Access Compliance Report Public Rights-of-Way (Curb Ramps)

Main Street: KENSINGTON_RD Cross Street: SHAKESPEARE_DR Location: E

ADA ID: RPAT211201102113 Ramp Type: Type 1 - Perpendicular Diagonal Initial Pass/Fail: Fail Overall Compliance: No Severity Score: 16

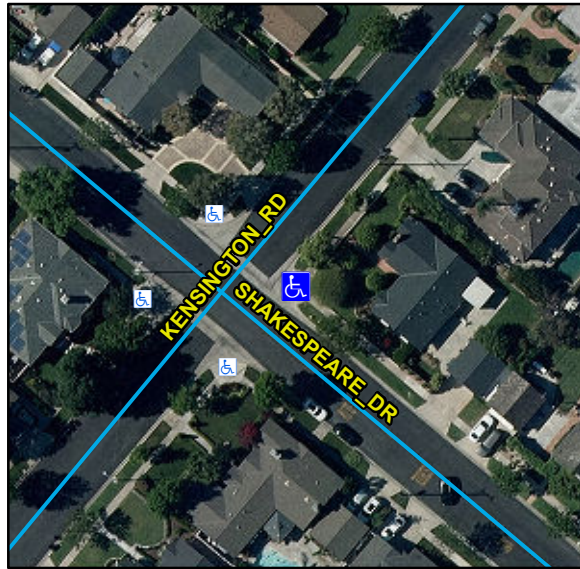
R304.2.2, R204.3, R304.5.3, STD 1115

Compliance	Description	Data	Compliance	Description	Data
N/A	Ramp Length (in)	83	N/A	Flare Type LT	
Yes	Ramp Width (in)	49			N/A
No	Ramp Run Slope (%)	9.3	N/A	Flare Slope LT (%)	N/A
No	Ramp Cross Slope (%)	3.5	N/A	Flare Traversable LT	N/A
N/A	Landing Present	N/A	N/A	Flare Type RT	
N/A	Landing Length (in)	N/A			N/A
N/A	Landing Width (in)	N/A	N/A	Flare Slope RT (%)	N/A
N/A	Landing Run Slope (%)	N/A	N/A	Flare Traversable RT	N/A
N/A	Landing Cross Slope (%)	N/A	N/A	DWS Provided	N/A
N/A	Landing Movement Obstructed?	N/A	N/A	DWS Contrast	N/A
	Landing Movement Type	N/A	N/A	DWS Length (in)	N/A
N/A	Landing Shared	N/A	N/A	DWS Full Width	N/A
N/A	Clear Space	Yes	N/A	DWS Offset Left (in)	N/A
N/A	Clear Space To Crosswalk (in)	N/A	N/A	DWS Offset Right (in)	N/A
N/A	Marked Crosswalk 1	No	N/A	Marked Crosswalk 2	No
	Crossing 1 Direction	NW		Crossing 2 Direction	SW
	Marked Crosswalk 1 Width (in)	N/A		Marked Crosswalk 2 Width (in)	N/A

Remove & Replace Curb Ramp With Two New Directional Ramps or Equivalent.
